**Re: Design Submission for Finlay Park, Naas, Kildare (the “Development”)
(the “Design Submission”) / Connection Reference No: CDS22004436**

We have reviewed your proposal for the connection(s) at the Development. Based on the information provided, which included the documents outlined in Appendix A to this letter, Irish Water has no objection to your proposals.

Appendix A

Drawing Title: PROPOSED FOUL AND SURFACE WATER LAYOUT

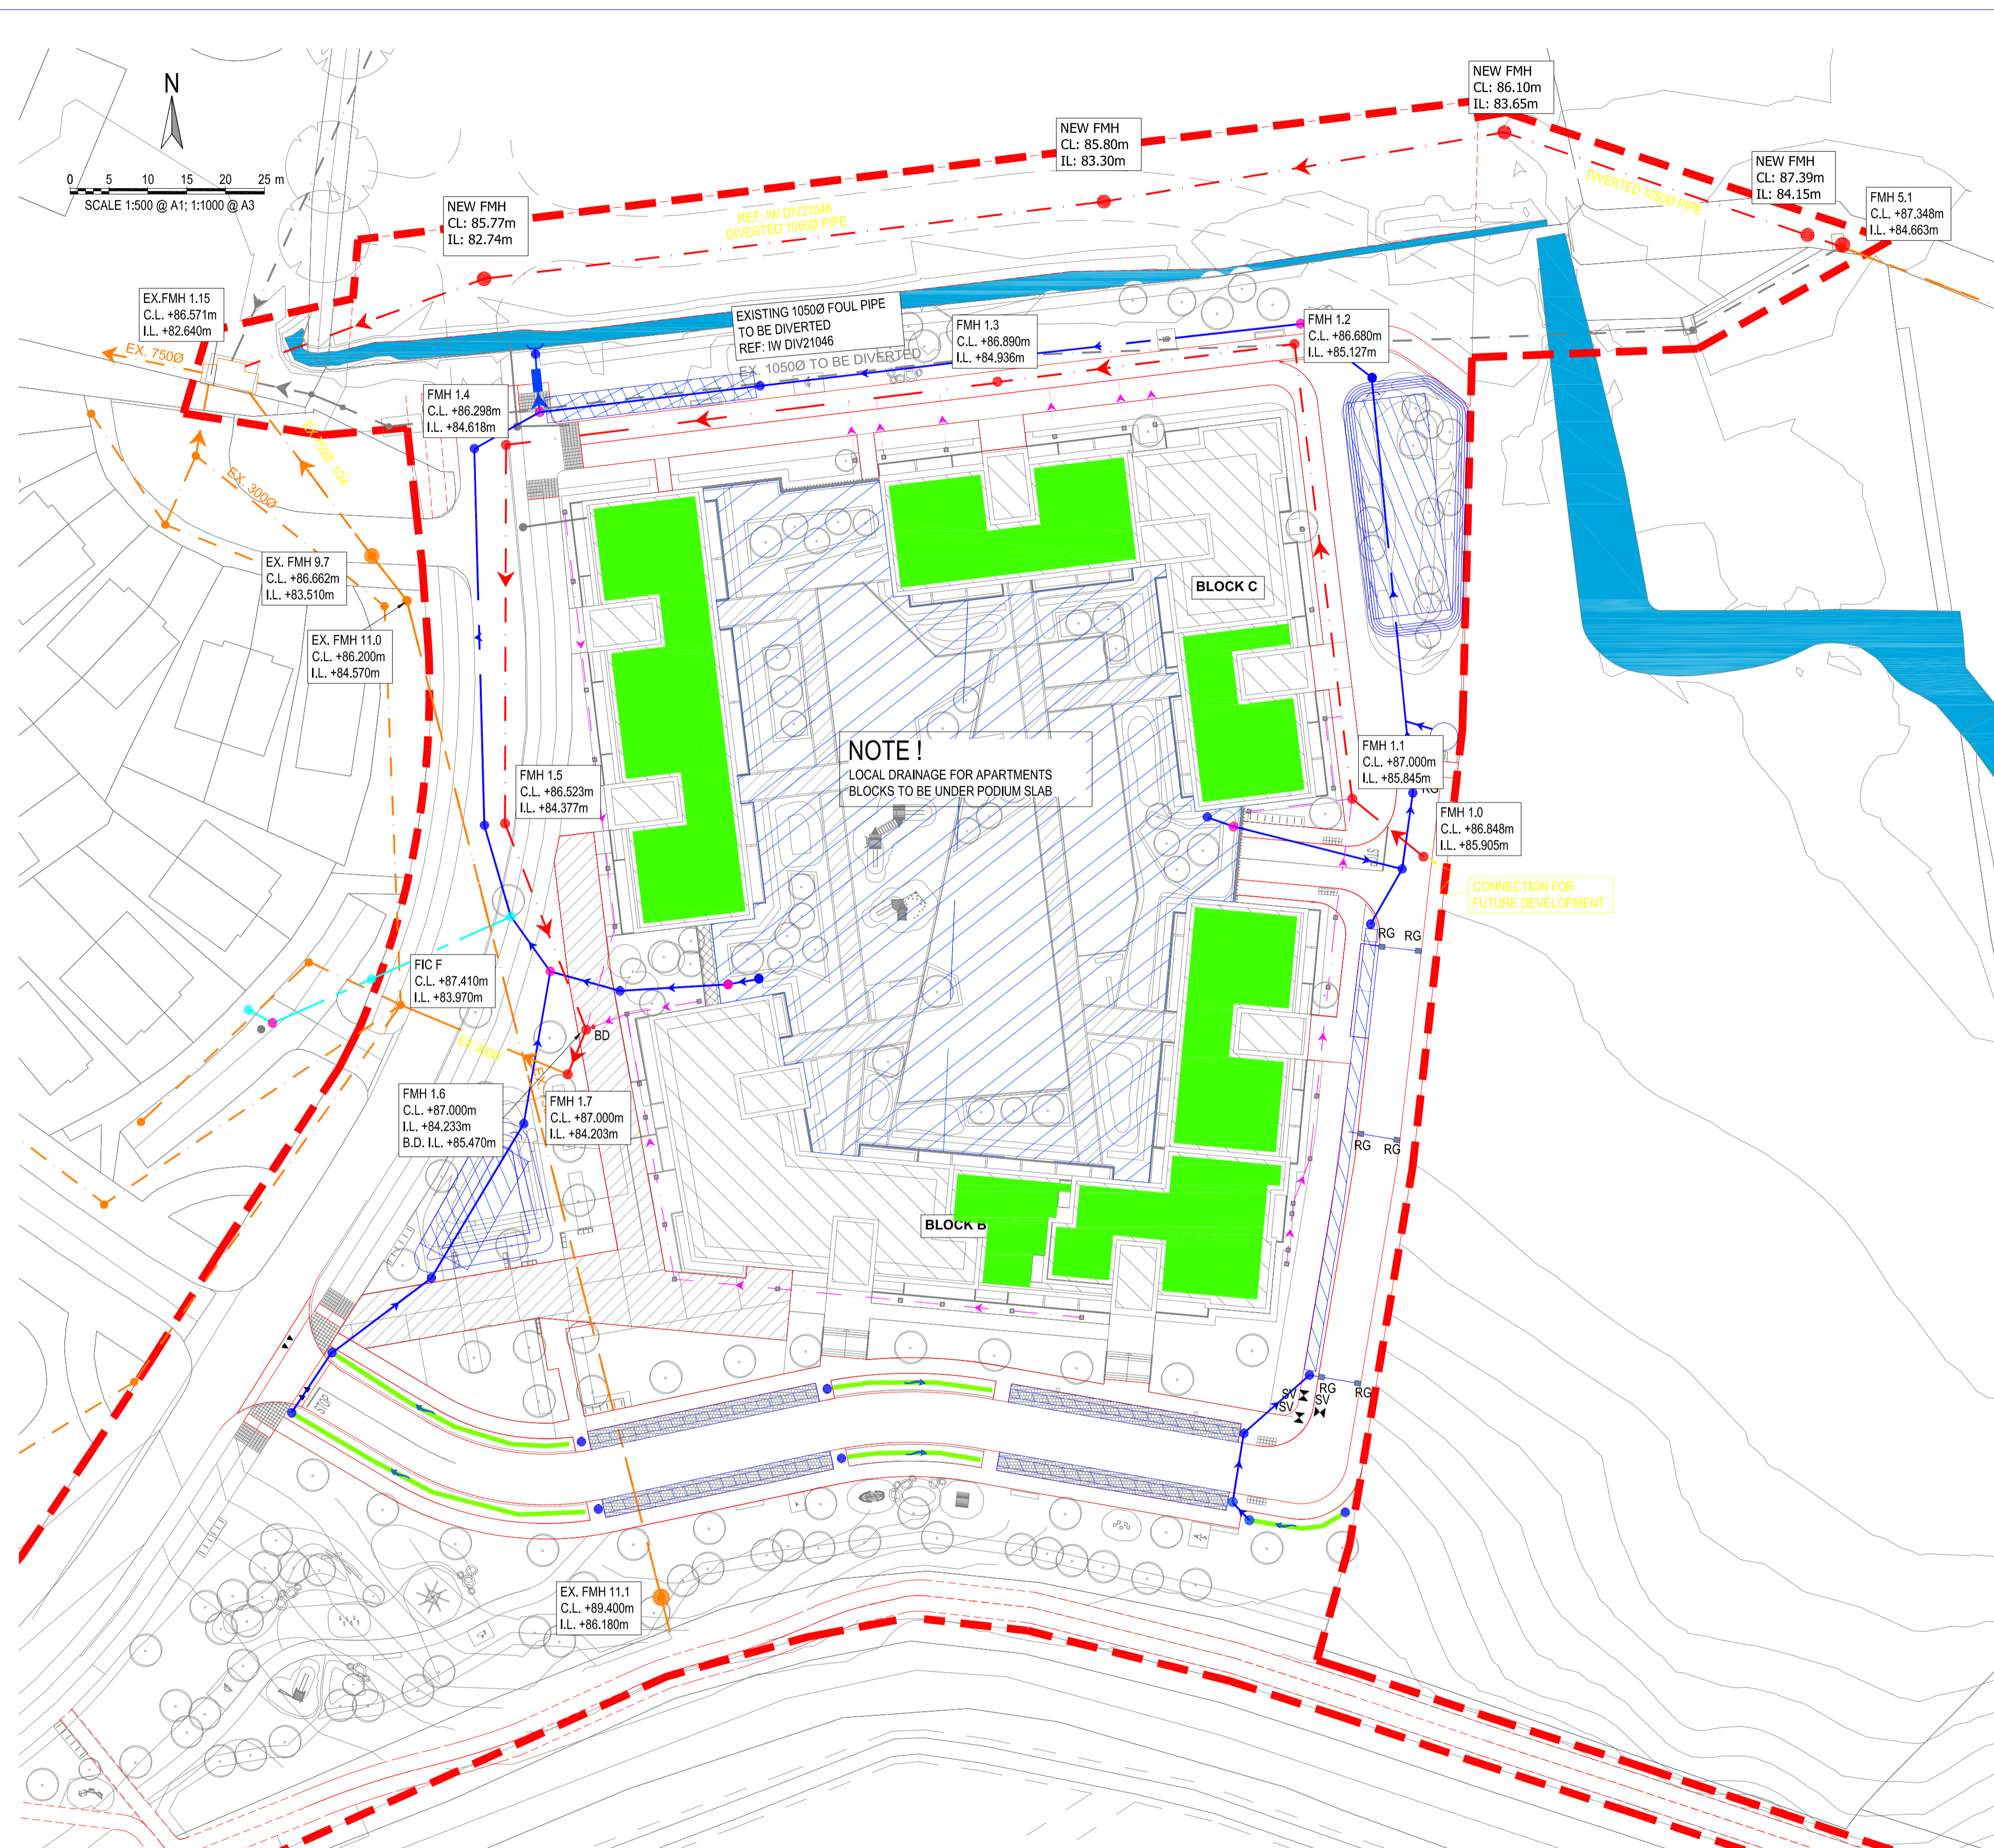
The design submission will be subject to further technical review at connection application stage.

Irish Water cannot guarantee that its Network in any location will have the capacity to deliver a particular flow rate and associated residual pressure to meet the requirements of the relevant Fire Authority, see Section 1.17 of Water Code of Practice.
